Geotechnical, Flooding and Stormwater Desktop Assessment for Proposed School Development

**1043 Linwood Road, Kingseat**

Job No: 20198 | Revision B | Dated 15 May 2020

**GEOTECHNICAL, OLFP FLOODING  
AND STORMWATER DESKTOP ASSESSMENT  
FOR PROPOSED SCHOOL DEVELOPMENT  
1043 LINWOOD ROAD, KINGSEAT**

**Figure 4: Feasibility Sketch with Overland Flow Paths**

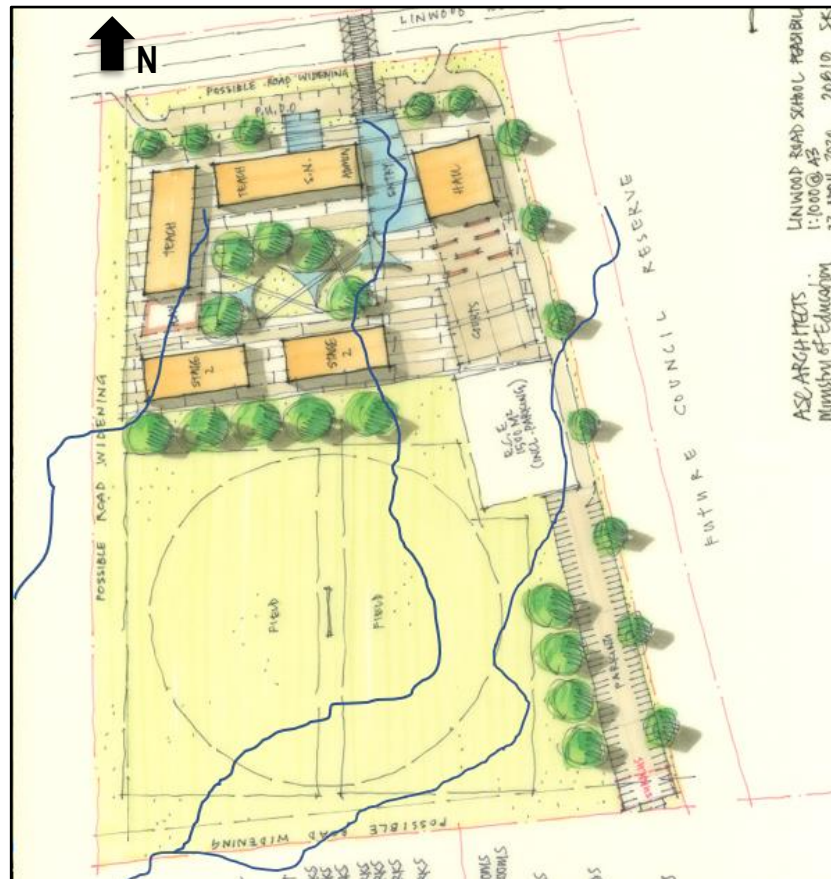
We have reviewed the received feasibility sketch of the school development (by ASC Architects dated 22 April 2020). Preliminary desktop review comments in relation to the OLFPs are:

- The three OLFPs are likely to be slightly obstructed by the currently provided feasibility sketch as shown in Figure 4, however the detailed development design is considered likely to differ from the feasibility sketch in order to OLFP manage site constraints. The potential impact on any future detailed development would largely be in respect to the development layout. Avoiding obstruction of the OLFPs and minimizing the impact of the OLFPs should be taken into consideration during the detailed design process in order to suitably manage the OLFP.

- OLFP diversion and conveyance assessment through the outdoor courtyard area/space between the buildings would be required to confirm the potential flood level and capacity for flow passage for each OLFP in relation to the proposed building (i.e. post-development site condition). Open channel swale will likely be required for OLFP diversion.

- A Hazard Risk Assessment in relation to the proposed development is required in accordance with the Auckland Unitary Plan (AUP) E36.9. (2), and will need to include (at a minimum):

- identification of the scale, frequency, and flow velocity of the OLFPs; assess potential flood risk to the proposed School;
  - Assessment of access, exit and safe evacuation routes of the proposed buildings during flood events;

- identification of site specific mitigation measures if any.
